Design & Access Statement Addendum

2205-LHA-XX-XX-RP-A-PL-002_P03

Prepared by Lechler Hayes Architects on
behalf of Tiger Developments Ltd.

This report has been prepared by Lechler Hayes Architects (LHA) in response to comments received from Manchester City Council Officers in relation to the design of the new Carmoor Road development. The comments received relate to the facade design and Cycle storage.

FACADE DETAILS - CARMOOR ROAD ENTRANCE

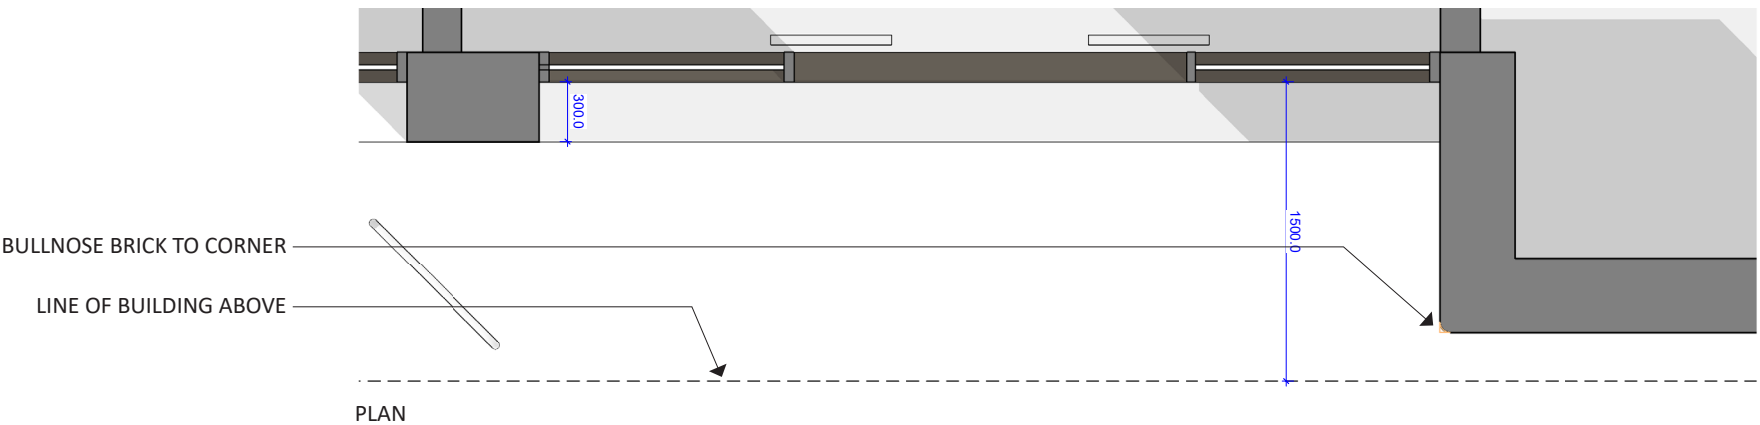
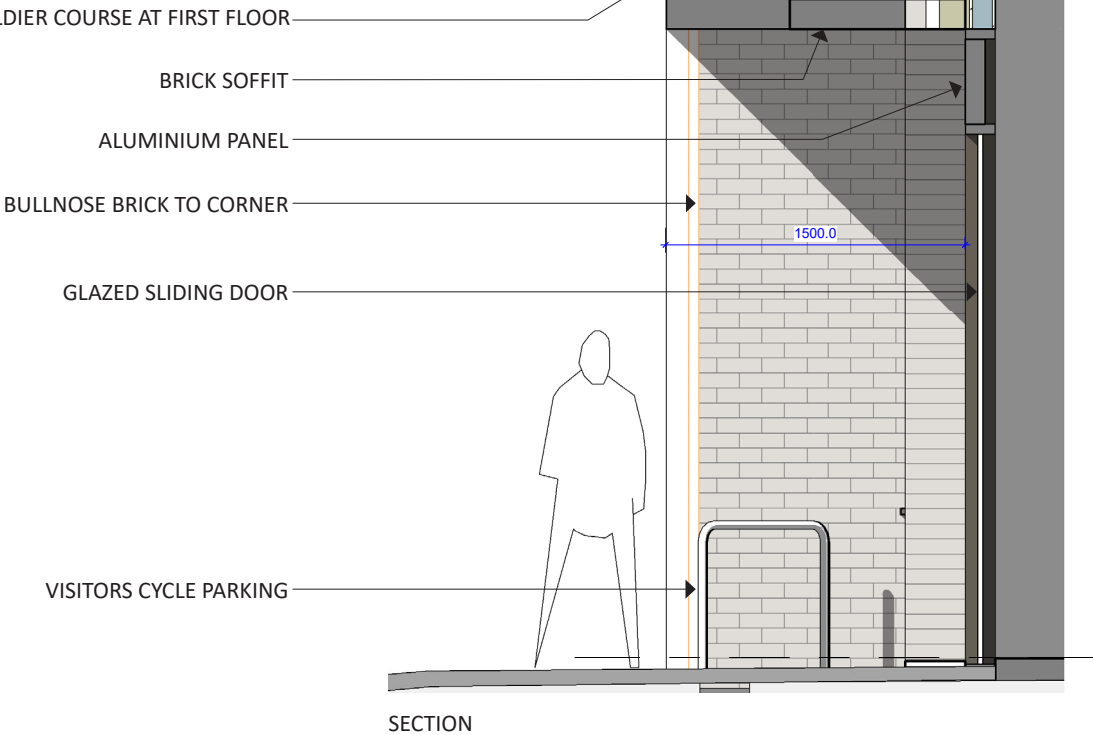
- MCC intend for this building to serve as a benchmark for future developments in Ardwick and therefore it should demonstrate depth, modelling and craft.
- Vertical emphasis is too pronounced on the submitted design and should be balanced with horizontal elements to create a masonry grid with deep window reveals and full height glazing.
- Metalwork is too dominant on the submitted design.
- The elevations should be simpler and more refined.
- The screen adjacent to the window should be decorative to provide interest to the facade.
- Ventilation should be set within a brick soffit or through air bricks in the brickwork.

The Carmoor Road Entrance is defined by a recessed area with large sections of glazing to activate the street frontage, create a clear and legible entrance, and provide an identifiable ground floor plinth.

A brick soffit is proposed to the set back area which will create a sense of solidity and weight in conjunction with deep window and door reveals.

The revised approach to the Carmoor Road entrance area has significantly reduced the extent of metal cladding and louvre screens when compared with the original design.
